Project: San Angelo ISD Paging Upgrade (RFP #26-008)

Subject: Addendum 01

TECHNOLOGY ITEMS FOR ADDENDUM 01

1 FLOOR PLAN - LAKE VIEW HS - BUILDING D
T121 1/8" = 1'-0"

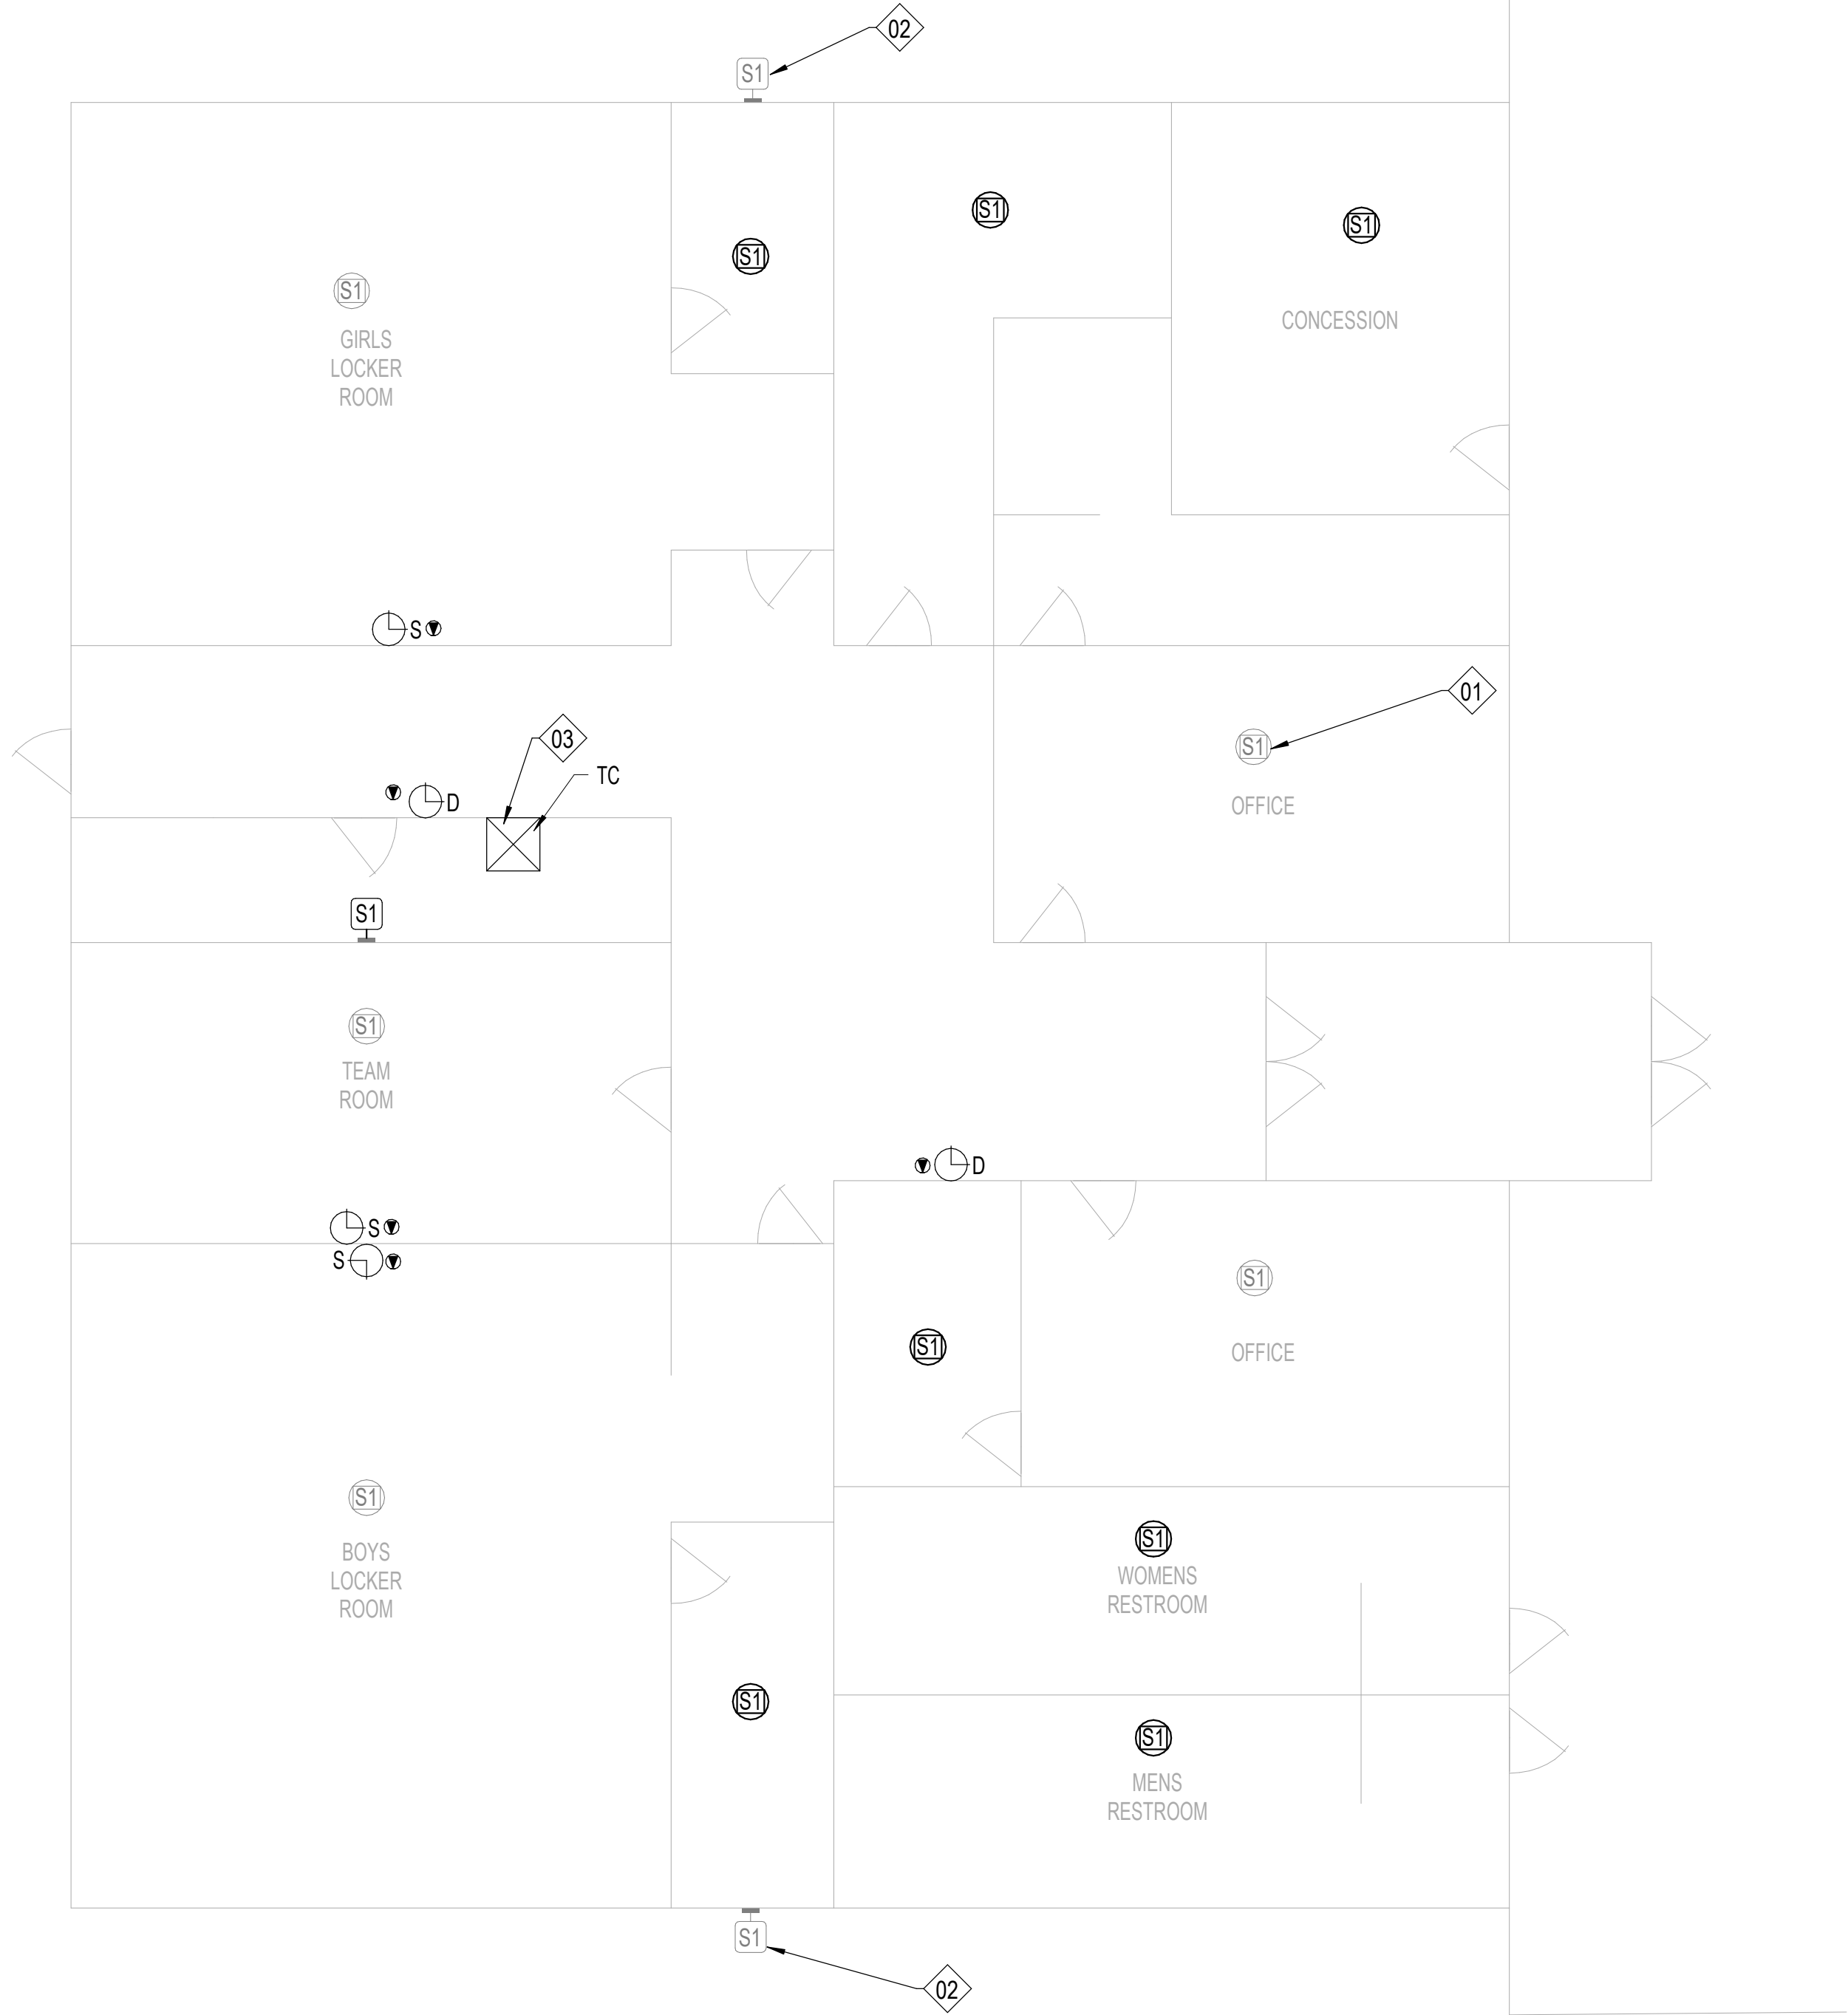
ADD No 1, Tech. Item 22: To the Drawings, Sheet T121, "FLOOR PLAN - LAKE VIEW HS - BUILDING D,"

- 1) Added halftone speaker clarification to Sheet Notes.
- 2) Added paint/finish clarification to Sheet Notes.
- 3) Clarified high-ceiling lift requirement item in Sheet Notes.
- 4) Modified/consolidated Keynote 16/17.

FLOOR PLAN - LAKE VIEW
HS - BUILDING G

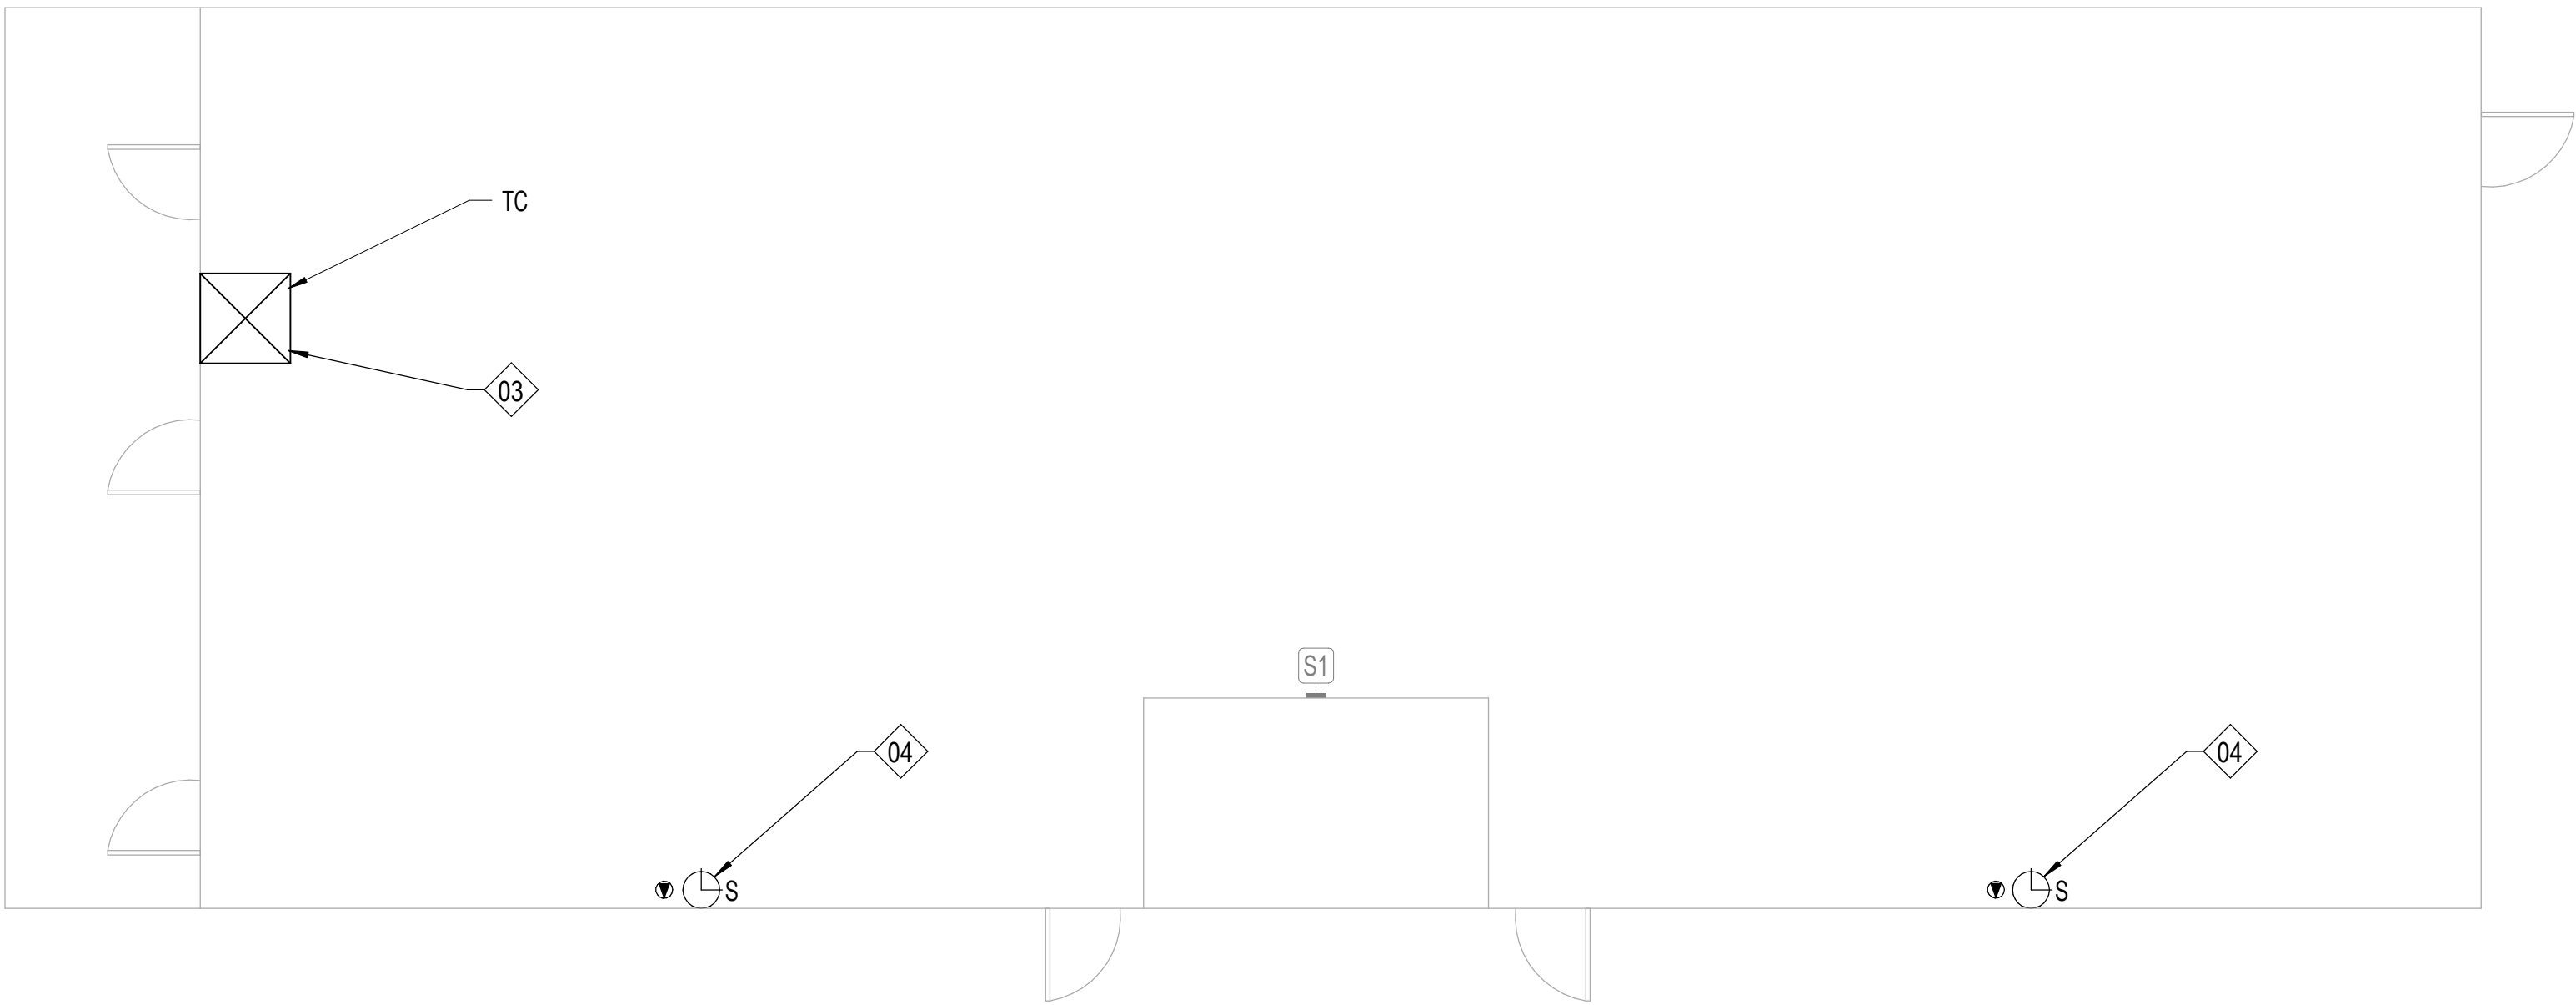
ADD No 1, Tech. Item 23: To the Drawings, Sheet T122, "FLOOR PLAN - LAKE VIEW HS - BUILDING G,"

- 1) Added halftone speaker clarification to Sheet Notes.
- 2) Added paint/finish clarification to Sheet Notes.
- 3) Clarified high-ceiling lift requirement item in Sheet Notes.
- 4) Modified/consolidated Keynote 16/17.
